# SERVICE BULLETIN

B-047

## SIDESTAND LEG FOR 2003 MODEL FIREBOLT (XB9R) (PRODUCT PROGRAM NO. BP8)

Figure 2. Old and New Sidestand Legs

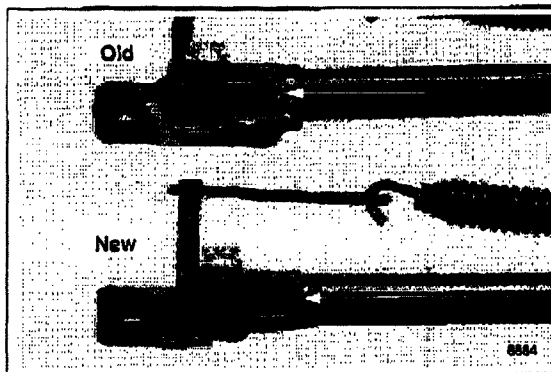
The Buell Motorcycle Company has elected to replace all sidestand legs on XB9R motorcycles, manufactured through July 9th, 2002. The new sidestand provides greater stability to the motorcycle when parked on sloped or uneven surfaces over and above the domestic/international standards with which it originally complied.

The part will be available on or before August 21, 2002. Part must be ordered as required and purchase price will be reimbursed through the warranty system. See CREDIT PROCEDURES. The replacement sidestand leg Part No. is: L0167.02A8.
